DESCRIPTIVE REPORT

Registry No. H12279

Descriptive Report to Accompany Survey H12279

Project: S-G904-NRT2-10

Figure 2: Prior Survey Coverage

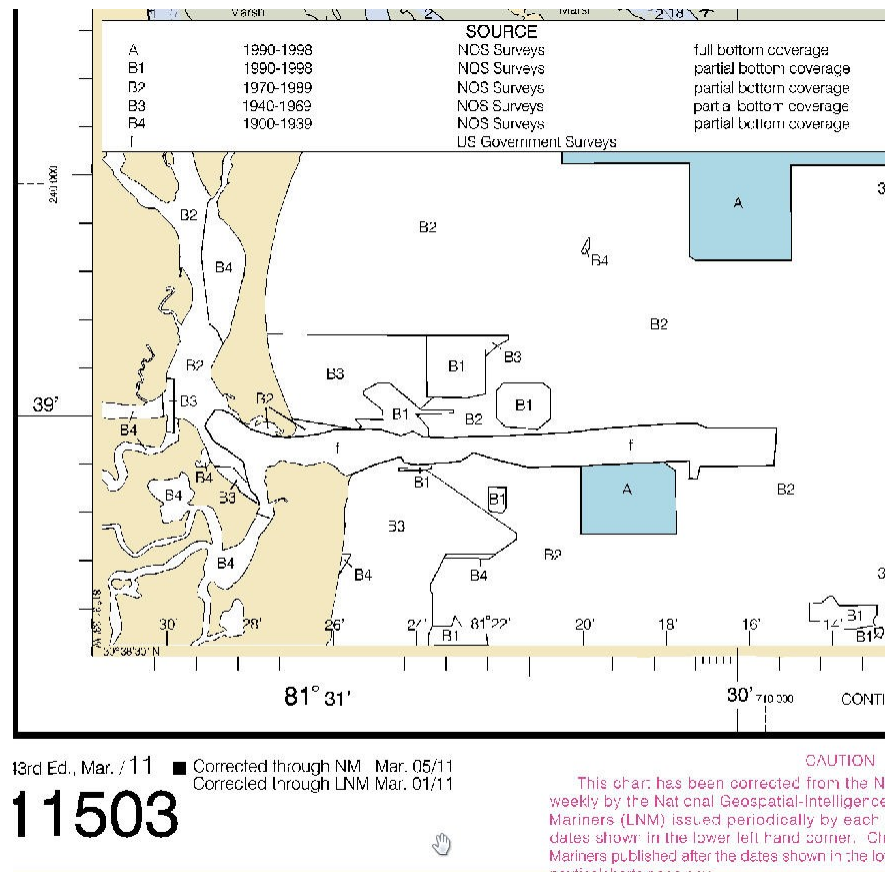
Last surveys in the area were 1970-1998 partial bottom coverage, and USCOE channel soundings.¹

- ¹ The latest chart has been updated with the latest controlling depths. (June 2011).
- ² Do not concur. Within the survey limits of H12279 there was no shoreline for investigation.

Figure 9: 35 ft Obsn

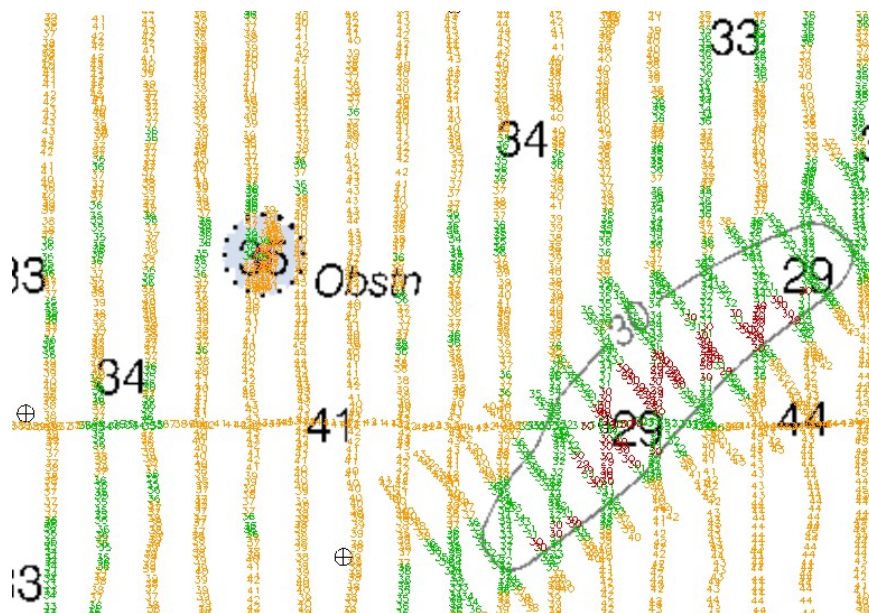
One charted 35 ft Obsn located at 30°42'16.42N 081°19'27.60W, was addressed, and validated.²² (fig 9)
A charted 30ft shoal in the vicinity of 30°42'10.049", -081°19'12.254" was developed. This shoal is receding in size, however still reflects depths of 28ft.²³ (fig 10)

- ²² An obstruction feature was added to the HCell to be retained.
- ²³ Chart soundings per HCell.
- ²⁴ Concur with clarification. See endnote 1.
- ²⁵ Chart soundings per HCell.

Figure 11: Channel Encroachment

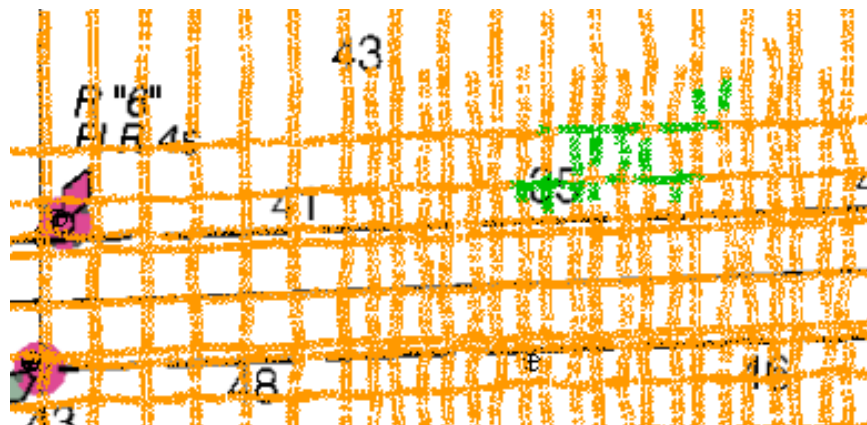
An area of channel encroachment in the vicinity of 30°42'45.105", -081°19'37.334", was developed. (fig 11)

The northern channel wall has the more pronounced slope, with minor intrusions southward into the channel. The Southern channel wall is less pronounced.²⁶

- ²⁶ Chart soundings per HCell.
- ²⁷ Concur with clarification. The Project Instructions state that a limited shoreline will be accomplished during data acquisition of H12279. However within the limits of H12279 there was no shoreline for investigation.

Figure 12: Missing LT GC "R5" Buoy

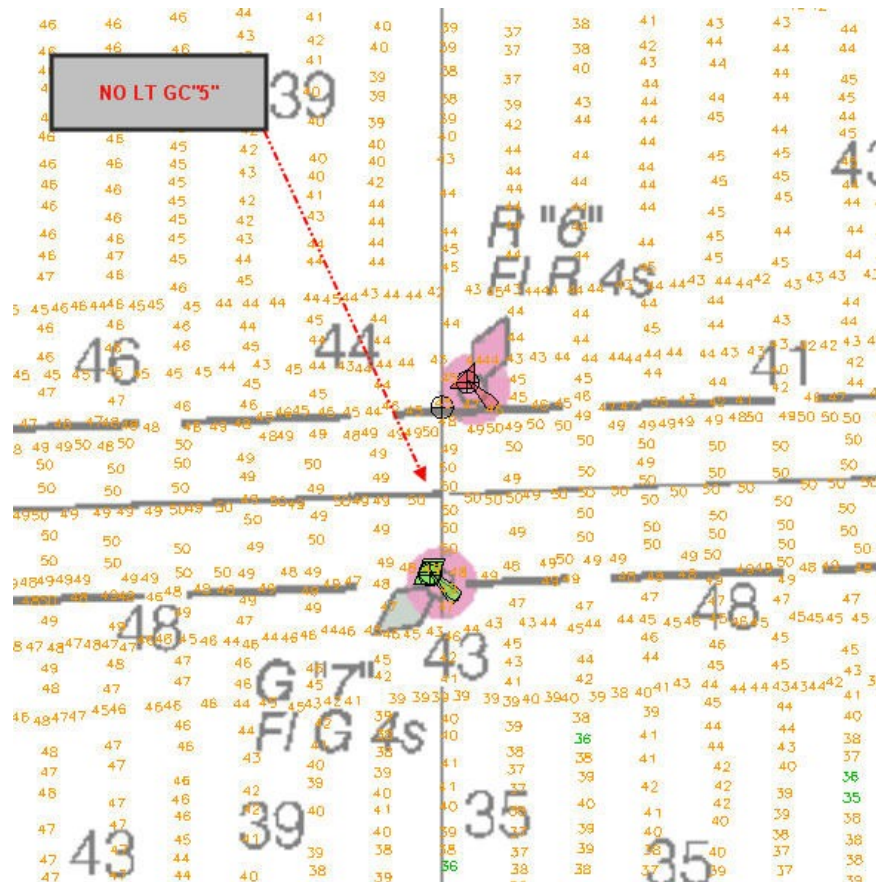
All ATONs were positioned for verification. All ATONs were found to serve their intended purpose. There is no LT GC"5" , it appears to have been omitted for the GC"7" instead. An ATON report was generated, and can be found in Appendix V.²⁸

- ²⁸ Chart ATONS according to the latest ATONIS information.
- ²⁹ Chart bottom samples per HCell.
- ³⁰ Data is adequate and within specifications to supersede charted data in the common area. Chart soundings per HCell.

Figure 13: Shell Fields.

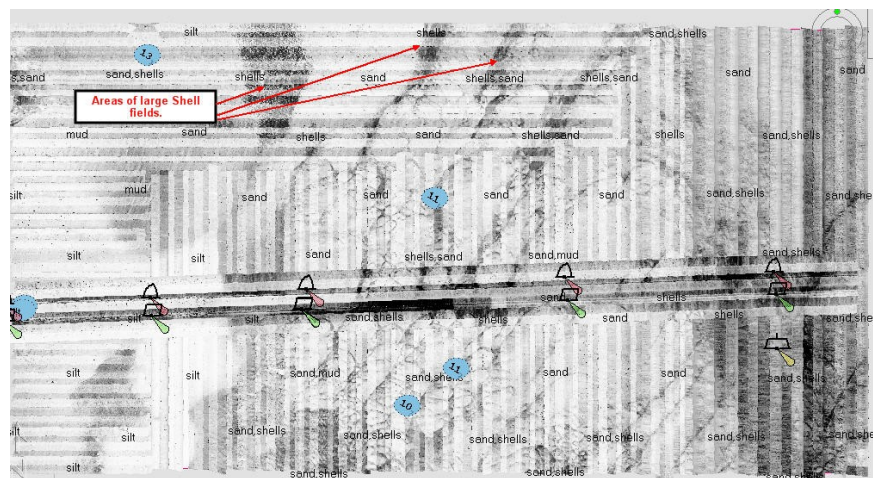
SSS OPS noted divergent areas in the bottom topography in the northern section of the survey. When the bottom samples are overlaid on the SSS mosaic, these areas were verified to be large shell fields, by bottom sample comparisons.²⁹
